**Dover Community Center
Peer Review
November 11, 2022**

Dover Community Center
4 Springdale Ave,
Dover, MA 02030

Final Bid Documents Peer Review

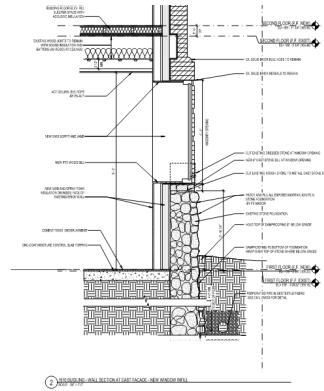
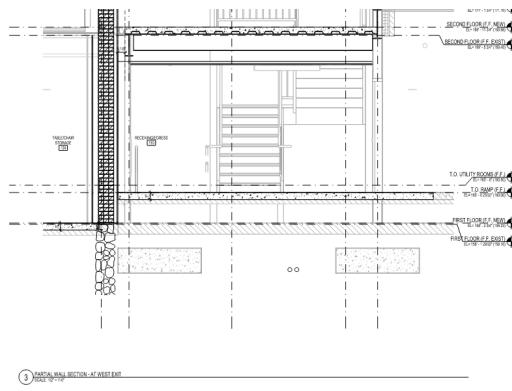
The scope of this peer review does not cover structural calculations but from experience, the structural foundation sizes appear large. As mentioned above, use of brick brings collateral cost impacts and a reason for the thick foundation walls is the 12' load bearing masonry wall which then has exterior insulation and brick cladding. The wall is twice as thick as would be a wall for a framed structure (with a framed structure other measures can be installed inside the recreation court to protect the walls). This would take more engineering design to exactly prescribe any savings but comparison of Dover's CC with a conventionally framed CC of similar size shows the concrete costs to be approximately \$50,000 higher for Dover.

The left image above shows the extent of load bearing masonry walls. The drawing on the right shows the foundation condition required for load bearing masonry and the attendant extra concrete material involved as compared to a conventional wall.

Simplify the Building “Shapes”

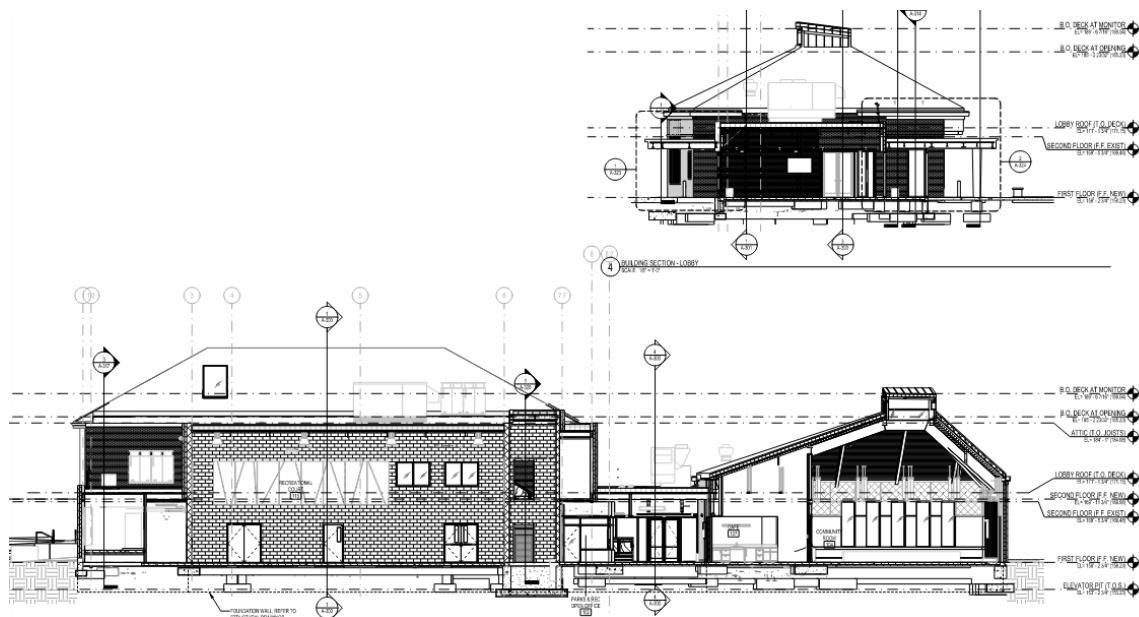
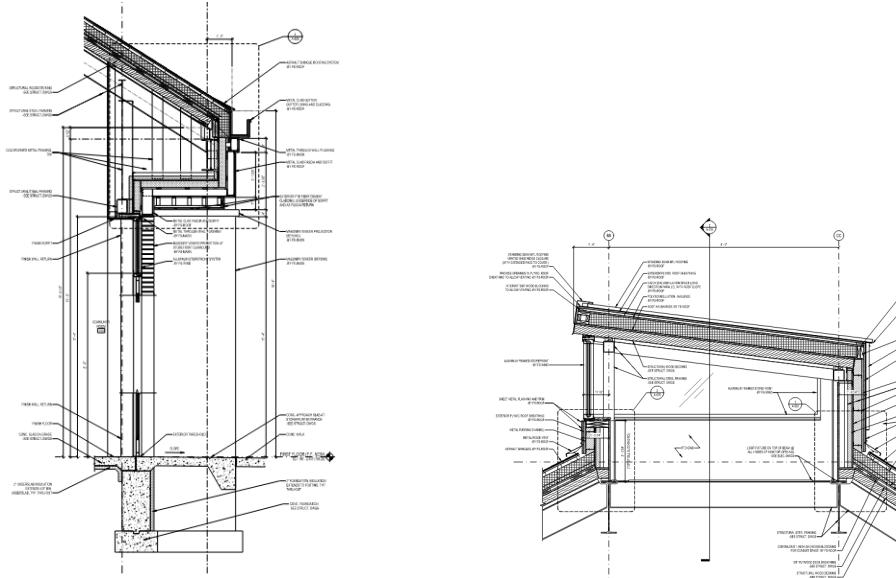
Sheet A317 and other sections reveal locations where new construction encroached on the existing rubble masonry foundation (see sketch below). This drawing appears to show the existing wall within the zone of influence from the new foundation wall. Excavating and forming this wall in such proximity to the existing foundation is difficult and likely accounted for in the cost. No cost savings has been attributed to this. However, if alternative structural systems were considered, the lateral bracing and attendant large footings could be re-examined.

Another way to consider slimming down the perimeter foundation is to thin down the 12" concrete block wall in the recreation court. As the wall is grouted and reinforced, it is likely that a thinner block may be useable resulting in savings. This is not yet factored into the cost analysis.

The drawing above left shows foundations near the rubble masonry wall. These large footings can only be poured after excavating the ground floor slab of the 1910 building. The right hand drawing shows exterior grade up against the masonry rubble wall. We suggest an interior or exterior water break wall for this condition as the earth against the perimeter should be lower in an ideal condition.

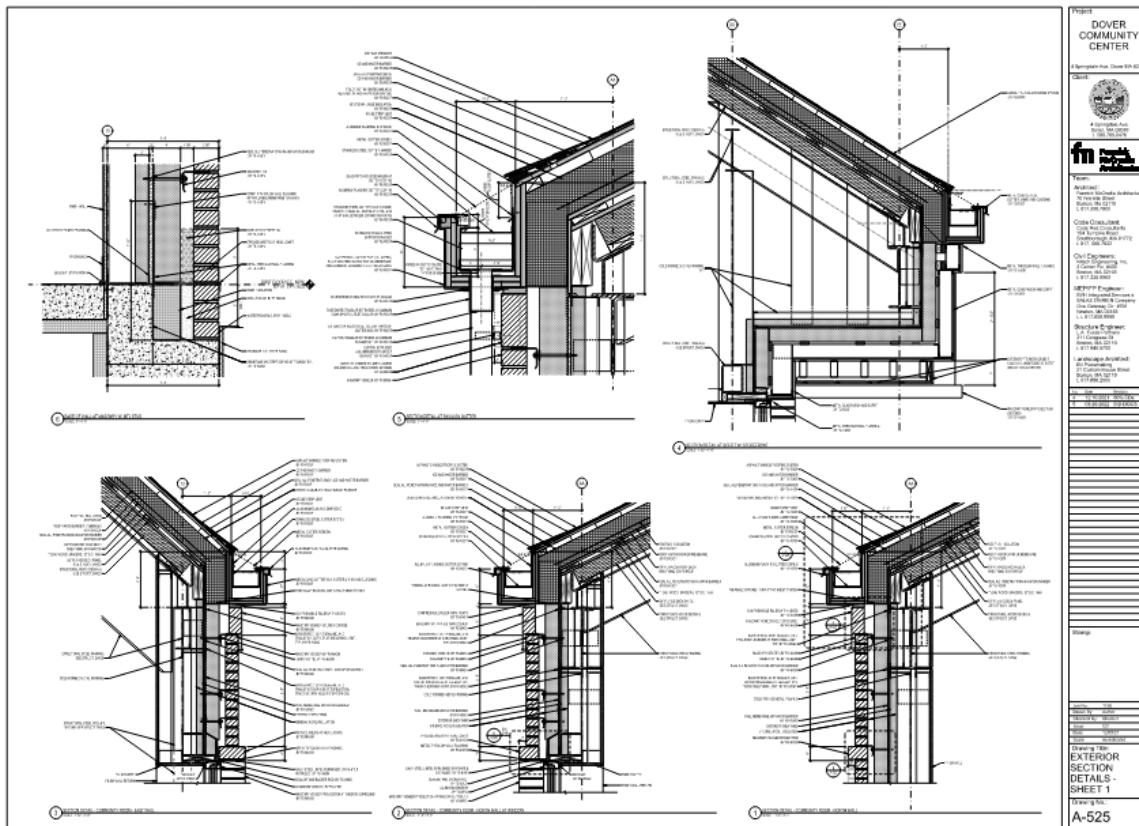
The above details show the roof monitor which brings with it metal roofing and a sub frame for its structure. The left drawing shows the complication of the perimeter wall. It is nicely designed and detailed but does add a cost factor to the project and alternatives are feasible albeit with a different aesthetic.

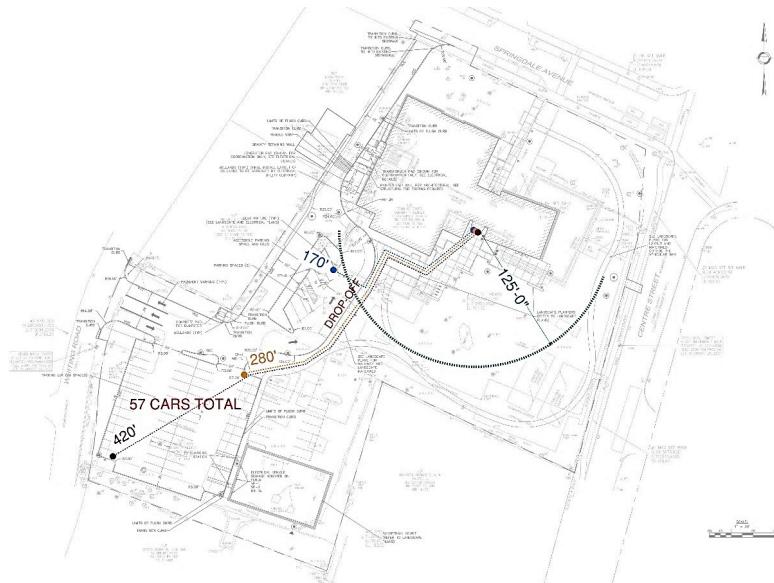
We would target the one-story element on the west side of the gym and do whatever is possible to reduce this area. Again, there is logic to the design. This area houses the water pump room, storage, electrical closet and parks and rec storage. The space totals 955 sf. If one assumes the water pump has to remain near this location, there may still be some space that can be eliminated.

Another option to consider is locating space on the second floor behind the elevator. This would be inexpensive space because you already own roof, walls, and foundations. They are just moved around if you add on the second floor and the sf cost is on the order of 50% of total new space.

With the storage calibration and the footprint reduction one could either save a significant amount of space or, get the recreation court within 500 feet of being a full useable court. With this option before them, the committee and Town could make an informed decision. Any of these options will require a recalibration of the thinking about this DCC.

The drawings below represent the as designed site parking as presented in the construction documents

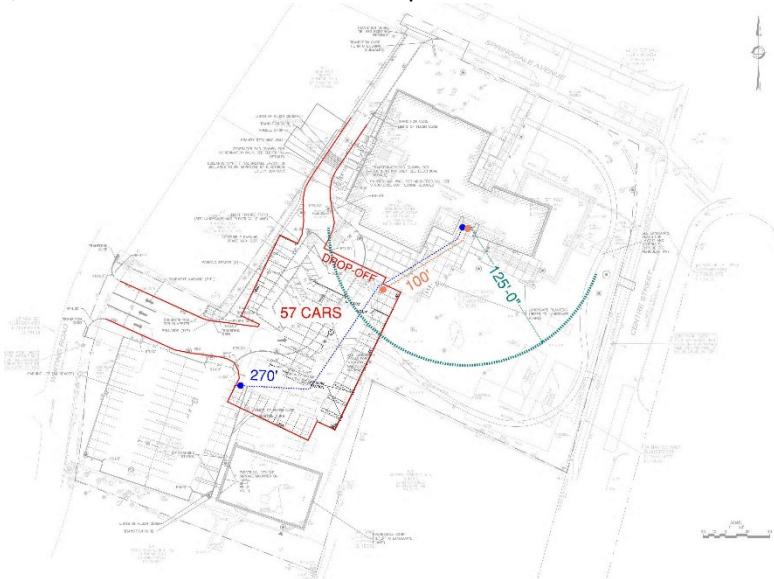
With the as designed site plan, the closest accessible parking space is located at a travel distance of 170 feet from the front door. The main parking lot with all of the non-accessible parking is at 280 feet from the front door to the first space with the rear corner being 420 feet from the door. This is a long distance for people to walk with mobility or weather-related challenges. We encourage Dover to study if this can be improved. We understand the benefits of reconstructing the existing paved area for the new lot but there are alternatives that would provide much improved drop-off and access to the front door for your users. Some examples are shown below.

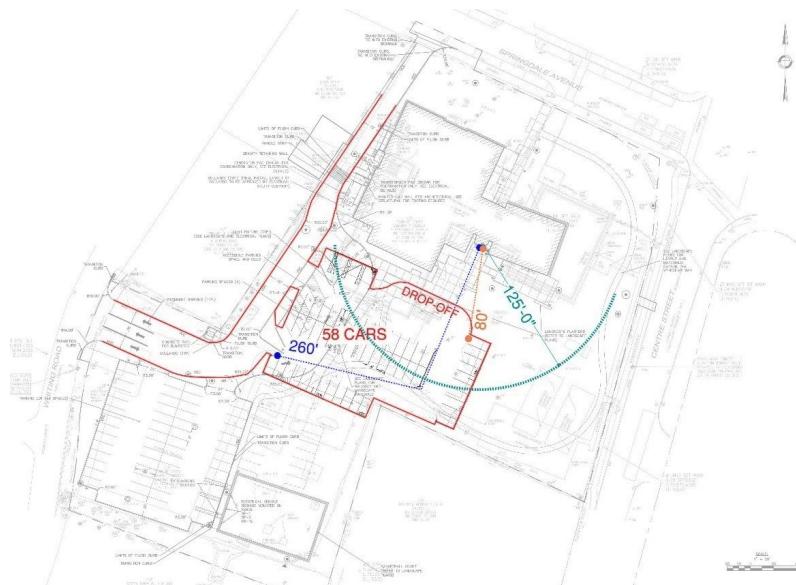
This drawing demonstrates an option to move the parking and drop off closer to the building entry for improved accessibility while reducing the scope of the sitework by reduction of paving, curbs, drainage, and sidewalks. It maintains the paved areas outside of the MPR.

First and second floor plans showing open and circulation space in yellow with storage and mechanical rooms in blue.

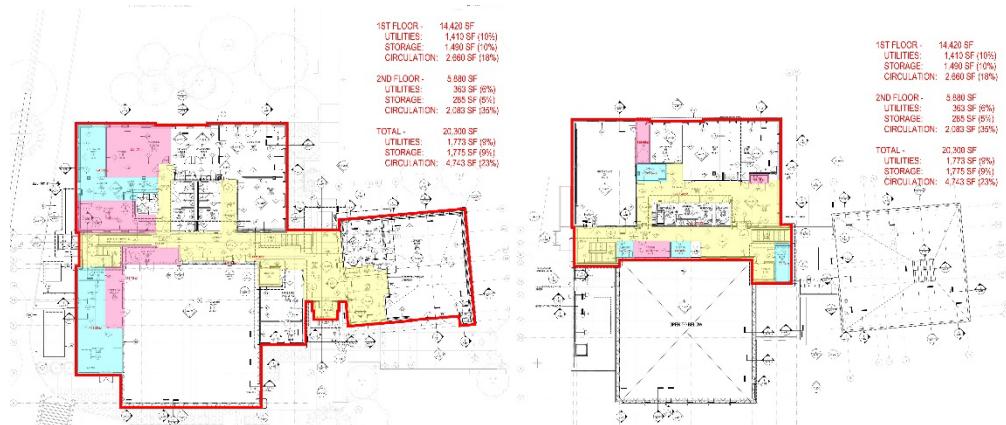
Storage and Utility space are important, but due to their overall cost to the project, one might study if these spaces can be made more efficient. The same goes for circulation; this is a large area for non-program space. As a point of comparison, a 28,000 sf community center with gym has 450 sf of total utility/mechanical space. There is no sprinkler pressure tank at the referenced CC but, the difference in space allocation is 4-fold.

Some potential plan diagrams below suggest that the floor layout may yield a higher level of program space especially on the second floor.
